DUKE POWER COMPANY

Re: Catawba Nuclear Station
Docket Nos. 50-413 and 50-414

Response to Request for Additional Information Regarding
EPZ Size and Configuration for
Catawba Nuclear Station

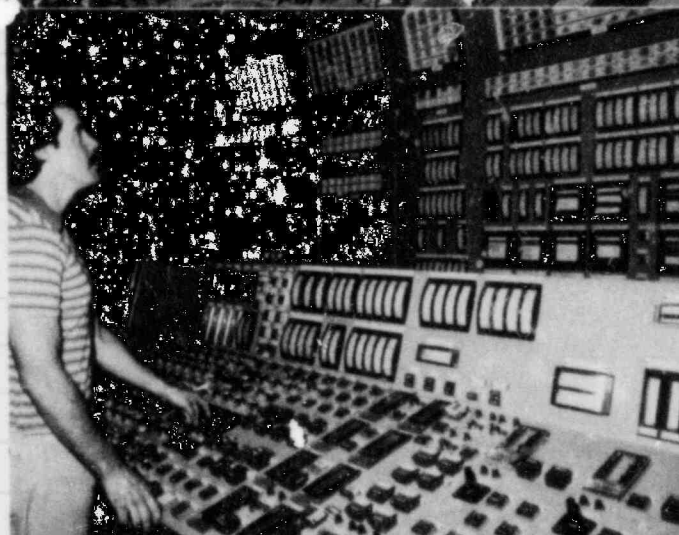
- 810.55 Discuss in detail how you have used the factors in 10 CFR 50.47(c)(2) in determining the size and configuration of the EPZ.
- 810.56 Discuss in detail if one or more of the factors were not used, and why not.
- 810.57 Discuss in detail whether State and local government officials participated in the determination of the EPZ boundaries.

The Catawba Nuclear Station Plume Exposure Emergency Planning Zone (EPZ) was configured to take into account local emergency planning needs and capabilities as they are affected by such conditions as demography, topography, land characteristics, access routes, and jurisdictional boundaries.

The Catawba EPZ was developed by North Carolina, South Carolina, and local planners. Duke Power Company took a retrospective view of the proposed layout and made certain suggestions to the planners to ensure the EPZ was configured to follow the guidance in 10 CFR 50.47(c)(2). Specifically, Duke Power suggested the use of Fishing Creek as a major part of the SW boundary, and that in Mecklenburg County, public protective action zones be developed which follow a 2 mile, 5 mile, and about 10 mile distance rather than use operations zones which are based on supplemental warning capabilities.

The Catawba EPZ takes into account demography and jurisdictional boundaries in two ways. First, any city having a major portion residing in the 10 mile area was included in the formal EPZ. This philosophy allowed inclusion of all of Rock Hill, South Carolina; York, South Carolina; Clover, South Carolina; and Pineville, North Carolina. Secondly, by reviewing the population densities within 10 miles it was apparent that inclusion of these population centers considers the effects of demography. Jurisdictional boundaries of Mecklenburg, Gaston, and York Counties were used to form individual zones within the EPZ.

There were no special considerations of topography, land characteristics, or access routes required as the region is more aptly separated by governmental jurisdictional boundaries and adequate access routes are available in all areas as evidenced by the evacuation time study.

In summary, the planning that was used to establish the Catawba Nuclear Station EPZ takes into account the items referenced in 10 CFR 50.47(c)(2).

Charlotte was not considered to be a part of the Catawba EPZ for several reasons. First, the outermost jurisdictional boundaries of Charlotte were no closer than 9.7 miles and in most cases along the NE sector were 11 or more miles away. Secondly, demography, in terms of population density, does not exceed 2000 people per square mile up to 14 miles from Catawba in the Charlotte sector. Further, there were no special topographical, land, or access route considerations that would have caused Charlotte to be included. Finally, when the NRC and EPA Task Force wrote NUREG-0396 (which formed the basis for the "about 10 mile distance" referenced in 10 CFR 50.47(c)(2)) and evaluated the necessary distance for the plume exposure EPZ, they made a summary statement as to the importance or necessity of planning outside of 10 miles. On page I-52 NUREG-0396 states,

"Although protective actions may be required for individuals located in areas further than 10 miles from the reactor, for an atmospheric release, the actual measures used and how rapidly or efficiently they are implemented will not strongly influence the number of projected early health effects."

Based on this statement and the fact that Charlotte has an emergency plan that provides for evacuation outside of 10 miles if the need arises (see R. M. Glover affidavit of November 3, 1983 for copy of City of Charlotte All Hazards Emergency Plan), it is not necessary to include Charlotte or a part of SW Charlotte into the Catawba EPZ.
